Arup - Fire Consultant

Cambridge Civic Quarter

RIBA Stage 2 Fire Strategy Report - Guildhall

Large Hall exit requiring upgrading

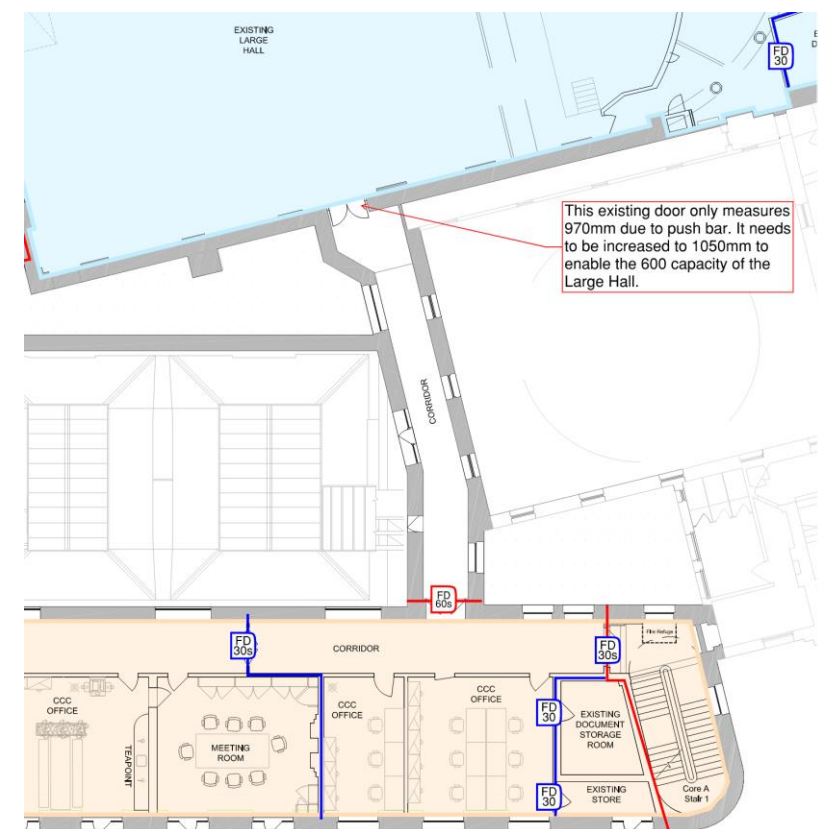
Protected lobby is required between stair and small hall. Could this be provided as a second set of doors within wall build-up?

Drawing Title
Proposed Basement 1 Plan

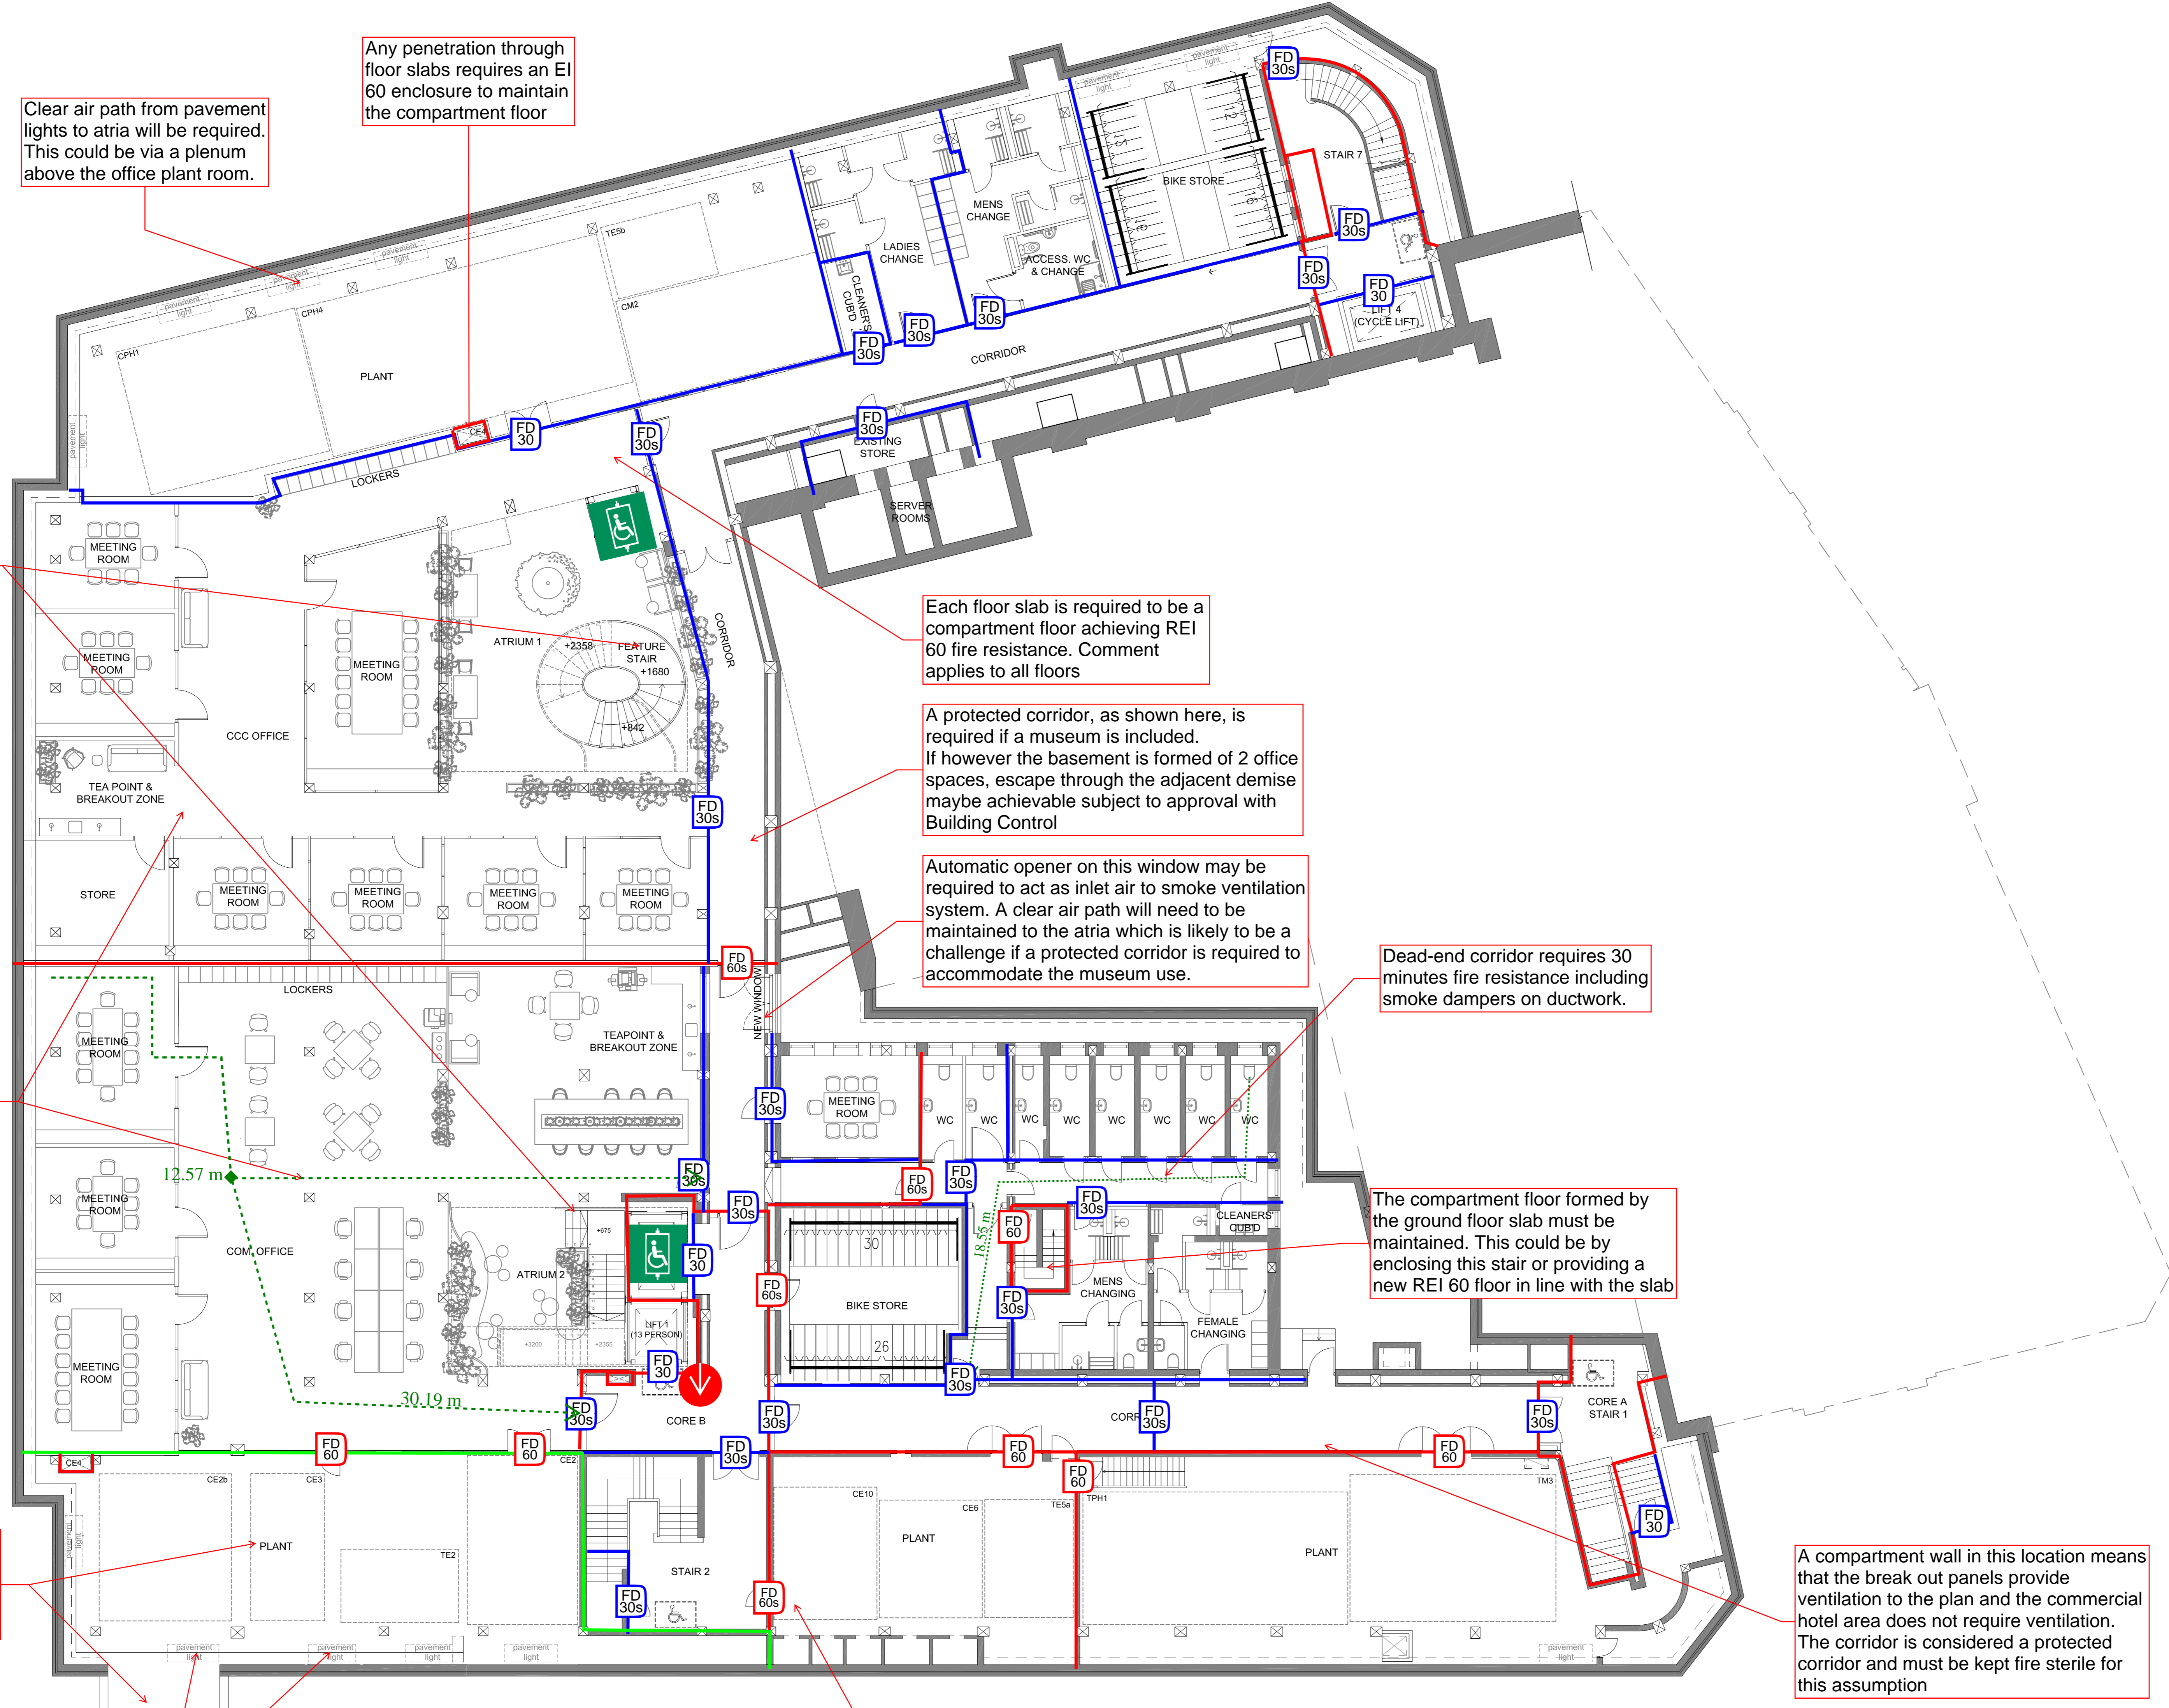
Clear air path from pavement lights to atria will be required. This could be via a plenum above the office plant room.

Any penetration through floor slabs requires an EI 60 enclosure to maintain the compartment floor

Basement smoke ventilation is proposed to be via 2 x new atria. See comments on roof for more detail.

Each floor slab is required to be a compartment floor achieving REI 60 fire resistance. Comment applies to all floors

Dead-end corridor requires 30 minutes fire resistance including smoke dampers on ductwork.

The compartment floor formed by the ground floor slab must be maintained. This could be by enclosing this stair or providing a new REI 60 floor in line with the slab

If this rooms provides back up power supply to life safety equipment, such as evacuation lifts, then it must be enclosed in 120 minutes REI fire resistance.

A compartment wall in this location means that the break out panels provide ventilation to the plan and the commercial hotel area does not require ventilation. The corridor is considered a protected corridor and must be kept fire sterile for this assumption

Drawing Title
Proposed First Floor Plan

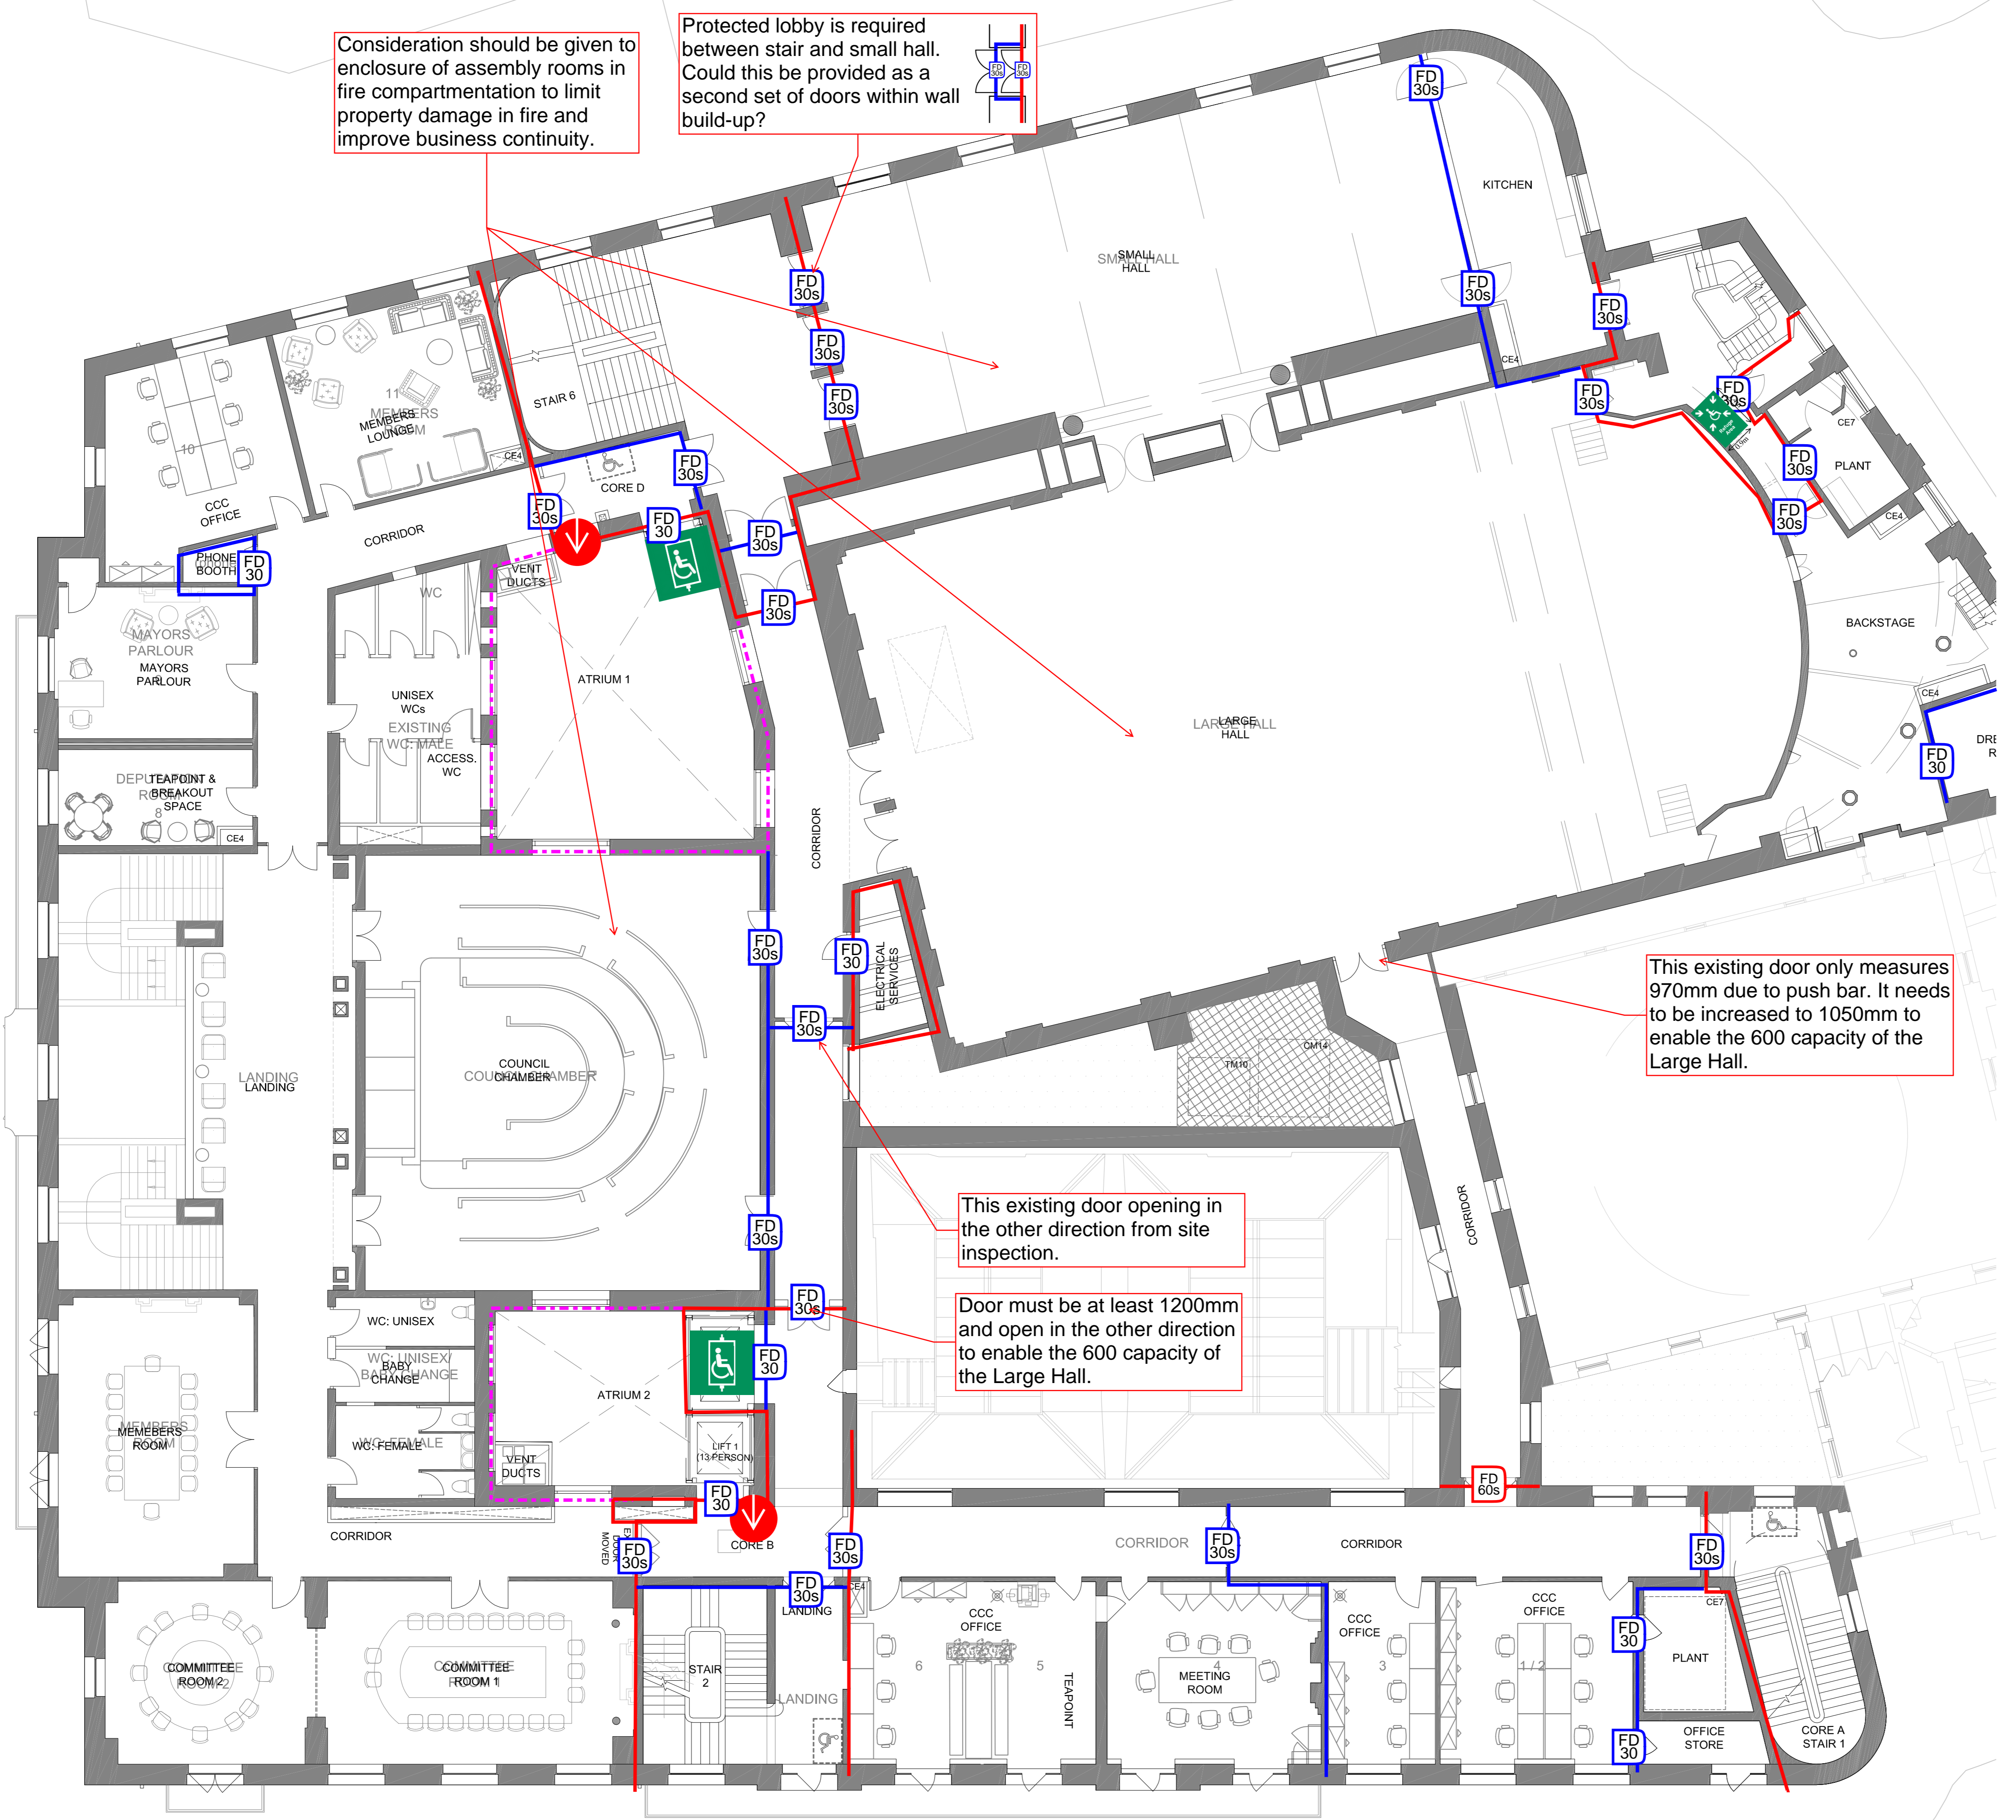
Consideration should be given to enclosure of assembly rooms in fire compartmentation to limit property damage in fire and improve business continuity.
